THREE MILE ISLAND NUCLEAR STATION UNIT 1

Operating License No. DPR-50  
Docket No. 50-289  
Technical Specification Change Request No. 9

TECHNICAL SPECIFICATION CHANGE REQUEST NO. 9

It is requested that the present TMI-1 Technical Specification pages 3-6, 3-7, 3-35, 3-35a, 3-36, and figures 3.5-2A, 2B, 2C, 2D and 2E be replaced with the respectively designated pages of the attached Appendix 1; and that a new figure 3.5-2F (previously designated figure 3.5-2E, and included in Appendix 1), be added to the TMI-1 Technical Specifications. Further, it should be noted that this Technical Specification Change Request, if approved, will serve to: (a) revise the present Power vs. Rod Withdrawal limits of the TMI-1 Technical Specifications Figures 3.5-2A, 2B, and 2C, and (b) revise the related Technical Specification text so as to be consistent with the revised figures.\*

CONTROL ROD GROUP WITHDRAWAL LIMITS  
FOR 4 PUMP OPERATION UNIT 1  
Figure 3.5-2A

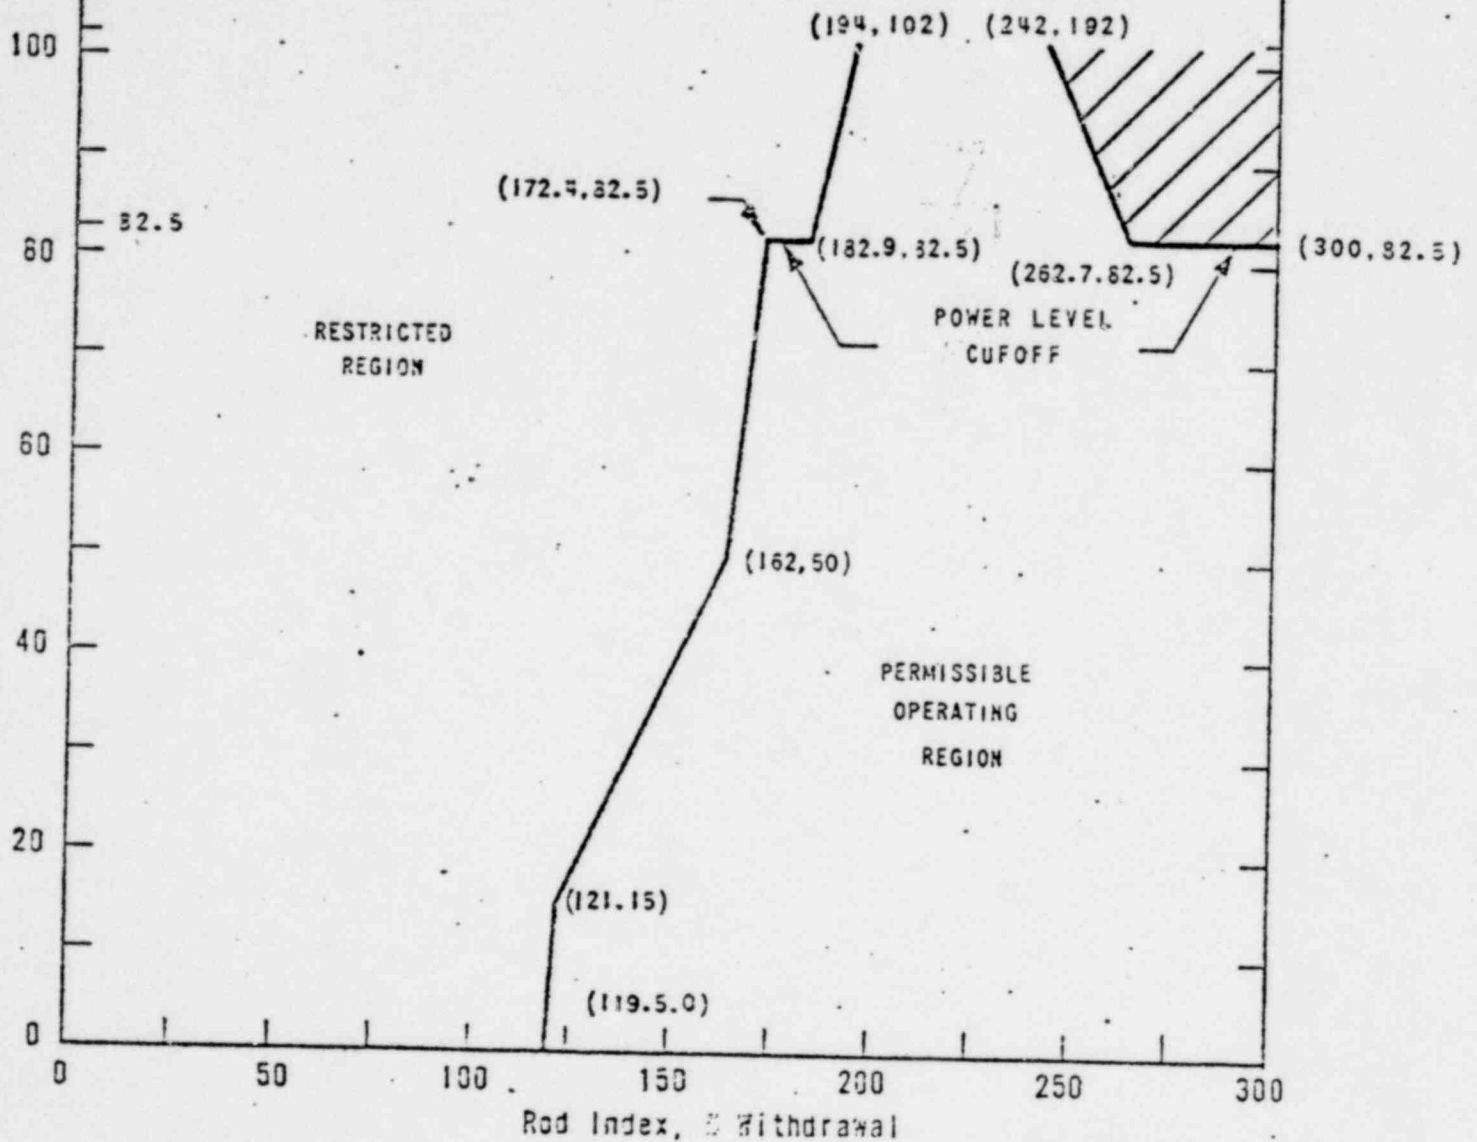
The present Power vs. Rod Withdrawal limits as provided by the present Technical Specification figures 3.5-2A, 2B, and 2C, are not adequate to ensure not exceeding the Technical Specification single rod worth limits of TMI-1 Technical Specification 3.5.2.3, for plant operations subsequent to the next control rod interchange (note: refer to Licensee Non Routine 30 Day Report 75-04, attached as Appendix II, for additional background in this subject area). The reason for this Change Request, therefore, is to obtain Power vs. Rod Withdrawal limits which are adequate to ensure not exceeding the rod worth limits of Specification 3.5.2.3 for plant operations in the time period from the first control rod interchange until completion of the first refueling.

1. Rod index is the percentage sum of the withdrawal of the operating groups.
2. The additional restrictions on withdrawal (hashed areas) are in effect after the control rod interchange. The restrictions on withdrawal are further modified after 440 full power days of operation (See Figure 3.5-2C)

Figure 3.5-2B

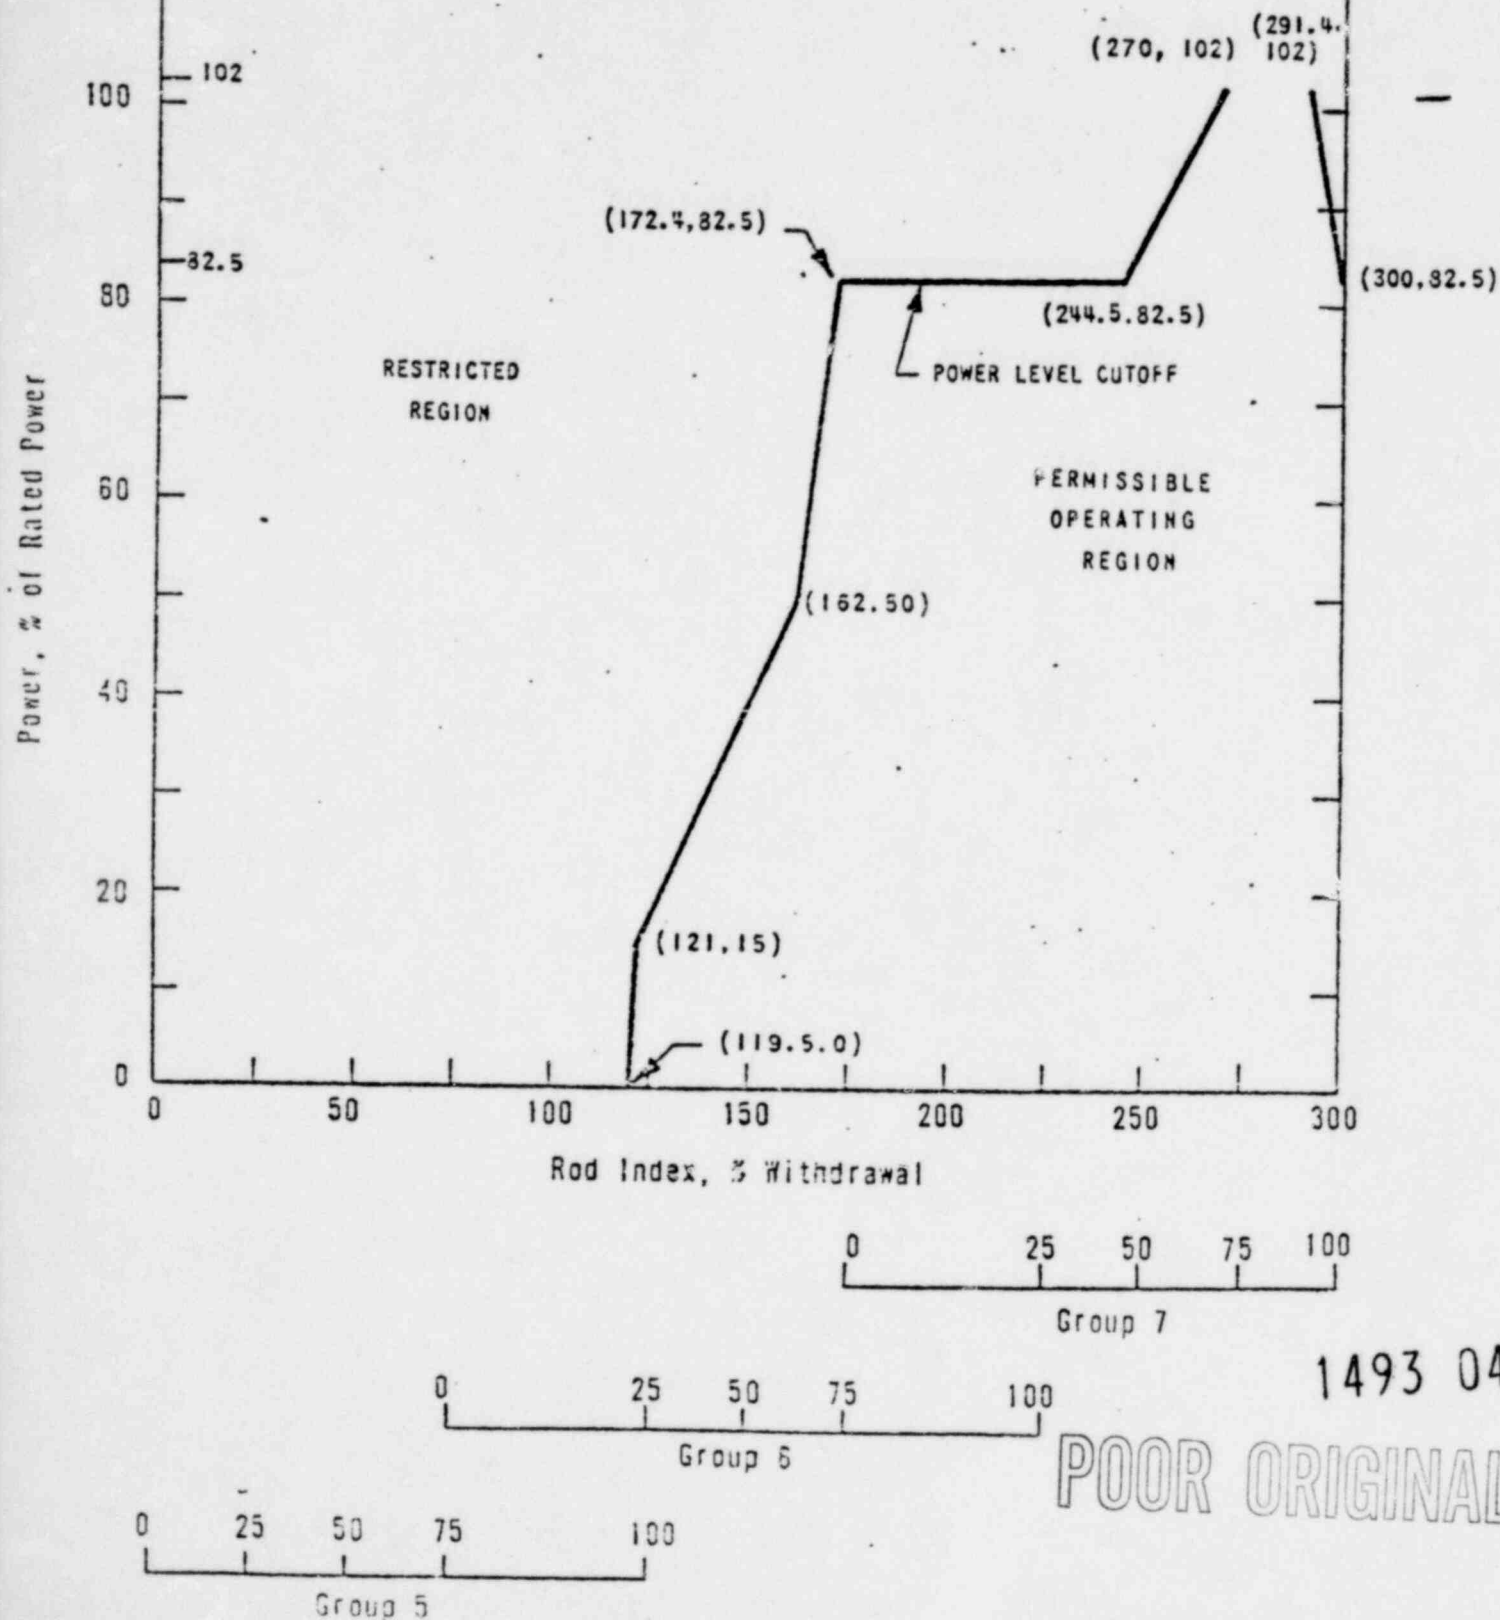
1. Rod index is the percentage sum of the withdrawal of the operating groups.
2. The additional restrictions on withdrawal are in effect after 440 full power days of operation.
